UNITED STATES PATENT AND TRADEMARK OFFICE

APPLICATION NO.	FILING DATE	FIRST NAMED INVENTOR	ATTORNEY DOCKET NO.	CONFIRMATION NO.
10/607,550	06/27/2003	Edward A. Burton	INTEL-021	7414
34610	7590	05/12/2005	EXAMINER	
FLESHNER & KIM, LLP			TRAN, LONG K	
P.O. BOX 221200				
CHANTILLY, VA 20153			ART UNIT	PAPER NUMBER
			2818

Office Action Summary

DETAILED ACTION

FIG. 6

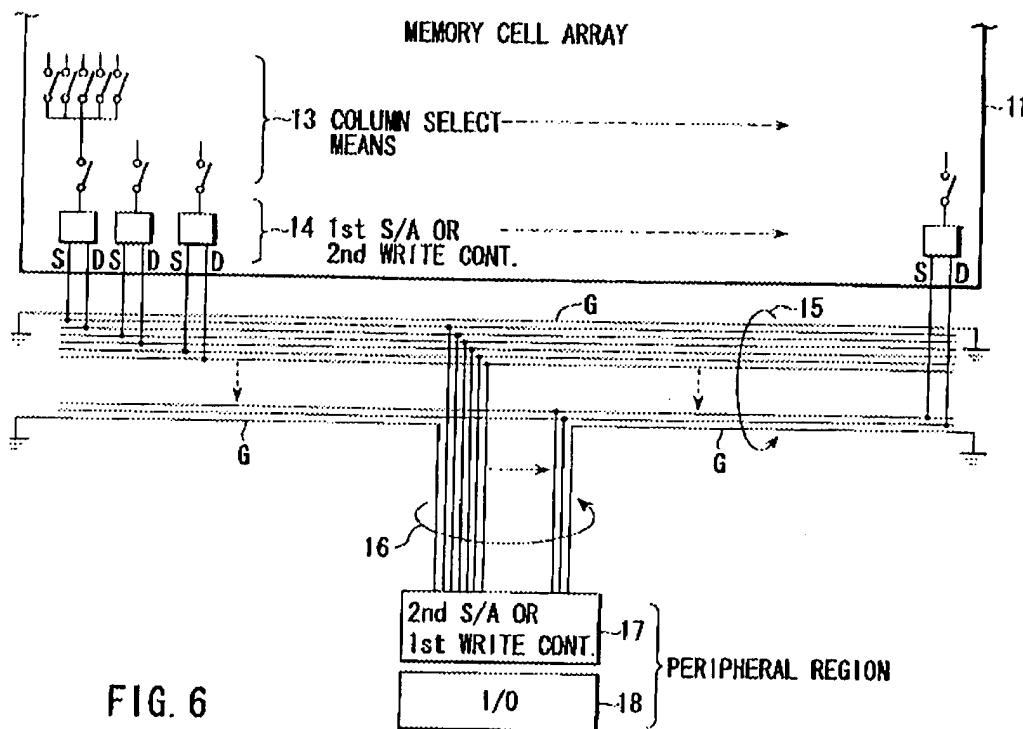
8. Claims **1, 3, 7, 8, 10, 11** and **12** are rejected under 35 U.S.C. 102(b) as being anticipated by Otsuka (US Patent no. 6,275,407).
9. Regarding claim **1**, the patent 407 illustrates a semiconductor device, comprising:
a first layer having a plurality of signal wires SENSE PAIR LINE (figs. 6 and 10B; col. 11, lines 11 – 383); and
a second layer adjacent to the first layer having a plurality of signal wires DATA PAIR LINE (figs. 6 and 10B; col. 11, lines 11 – 38), wherein the signal wires in the first

laver are substantially parallel with the signal wires in the second laver (figs. 6 and 10B; col. 8, lines 20 23 and col. 11, lines 11 – 38) and wherein adjacent signal wires are located in an alternating pattern in the first and second layers (fig. 6 and 10B; col. 8, lines 20 – 23 and col. 11, lines 11 – 38).

Regarding claim 3, the patent 407 illustrates the alternating pattern has every other signal wire residing in the same layer (fig. 6 and 10B; col. 8, lines 20 – 23 and col. 11, lines 11 – 38).

10. Regarding claim 7, the patent 407 illustrates a semiconductor device, comprising:
a first layer having a plurality of signal wires SENSE PAIR LINE (figs. 6 and 10B; col. 11, lines 18 – 38); and

a second layer adjacent to the first layer having a plurality of signal wires DATA PAIR LINE (figs. 6 and 10B; col. 11, lines 18 – 38), wherein the signal wires in the first layer are substantially parallel with the signal wires in the second layer (figs. 6 and 10B; col. 8, lines 20 23 and col. 11, lines 11 – 38); and

at least one additional layer S or D (fig. 6. Note: there are more than one SENSE PAIR LINE layer (S) and DATA PAIR LINE layer (D) that are parallel to each other in fig. 6; and they are identical to the SENSE PAIR LINE layer and DATA PAIR LINE layer in fig. 10B) adjacent to the first and second layer, wherein adjacent signal wires are located in an alternating pattern in the first and second layers (fig. 6 and 10B; col. 8, lines 20 – 23 and col. 11, lines 11 – 38).

Regarding claim **11**, the patent 407 illustrates the pluralities of signal wires SENSE PAIR LINES and DATA PAIR LINES in the first and second layer are a first set of signal wires configured to carry a first set of related signals (fig. 6).

Regarding claim **12**, the patent 407 illustrates the second set of signal wires being replicated in the first and second layers (fig. 6).

FIG. 10B

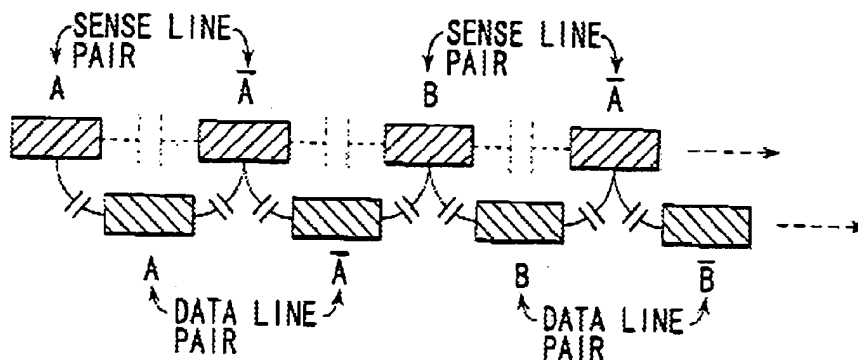
However, the patent 407 shows the adjacent signal wires are located in an alternating pattern in the first and second layers (fig. 6 and 10B; col. 8, lines 20 – 23 and col. 11, lines 11 – 38).

F I G . 4 D

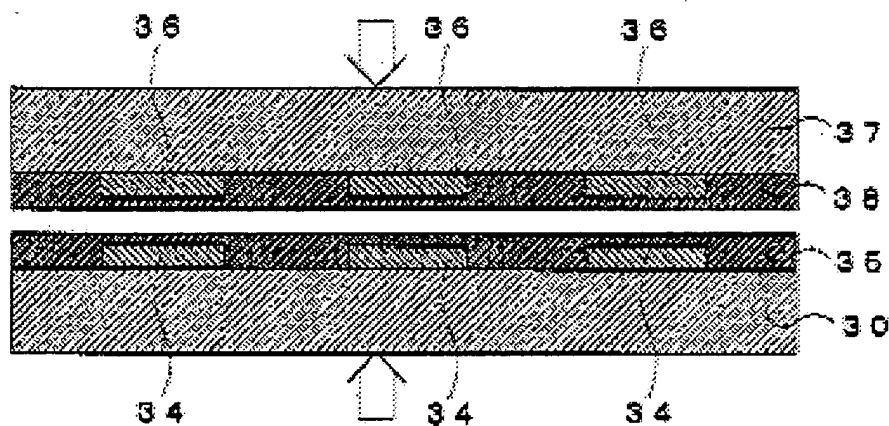
A first layer (not shown same as 35 (fig. 4D)) having a plurality of signal wires 75 (fig. 8), a second layer (not shown same as 38 (fig. 4D)) adjacent to the first layer having a plurality of signal wires 76 (fig. 8), wherein the signal wires in the first and second layers are substantially parallel with each other (column 9, lines 45 – 47).

A first layer (not shown same as 35 (fig. 4)) having a plurality of signal wires 75 (fig. 8), a second layer (not shown same as 38 (fig. 4)) adjacent to the first layer having a plurality of signal wires 76 (fig. 8), wherein the signal wires in the first and second layers are substantially parallel with each other (column 9, lines 45 – 47).

Regarding claim **30**, the patent 330 illustrates at least one additional layer adjacent to the first and second layer (not shown same as 35 (fig. 4)), wherein signal wires 77 (fig. 8) in the at least one additional layer are substantially parallel to signal wires in the first and second layers.
